SUBJECT: Limerick Generating Station, Units 1 and 2
Information for Auxiliary Systems Branch (ASB)
Regarding Technical Specification Surveillance
Requirement 4.6.1.4

Attached is a draft change to FSAR Figure 6.7-2 which is being made as a result of the referenced telecon.

FSAR FIG. 6.7-2
MSIV-LCS PROCESS
DIAGRAM

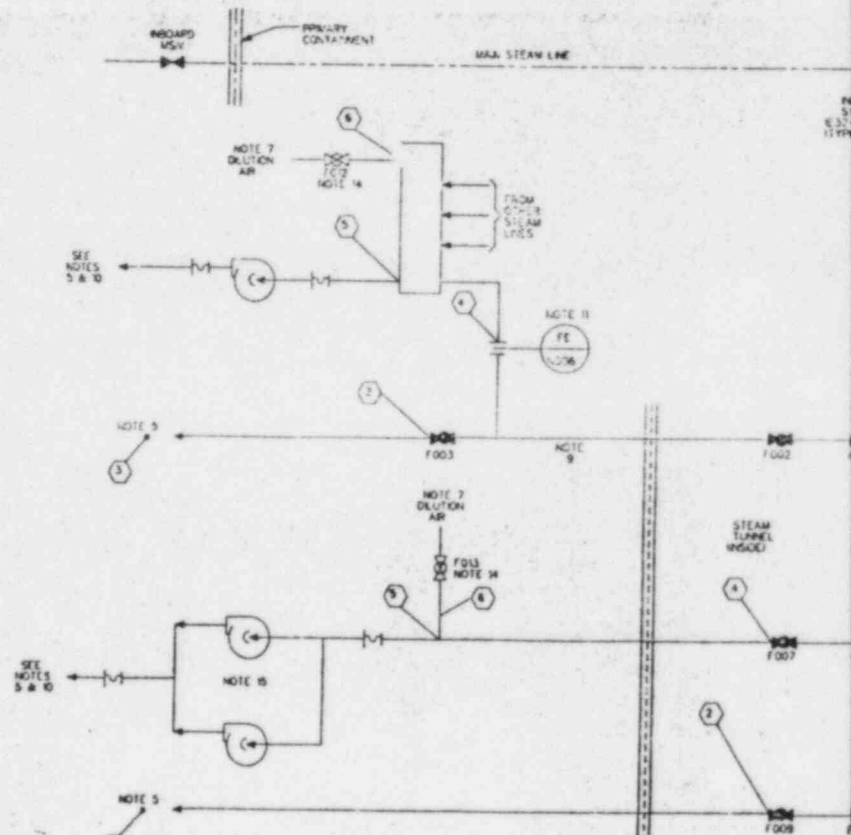
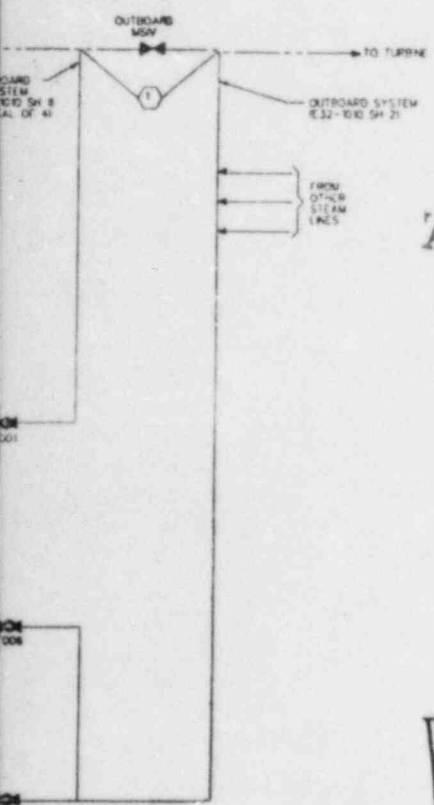
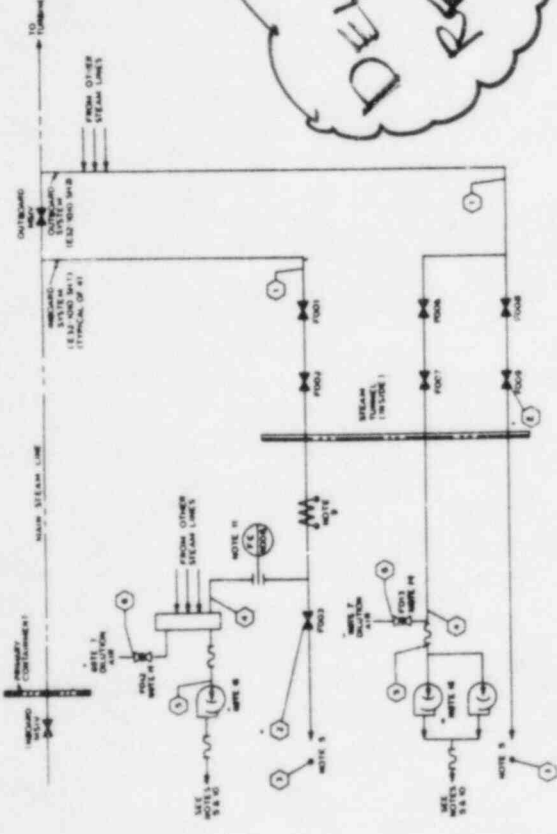
DELETE AND REPLACE WITH ATTACHED.

The information contained on this draft FSAR change will be incorporated into the FSAR, exactly as it appears on the attachment, in the revision scheduled for October 1984.
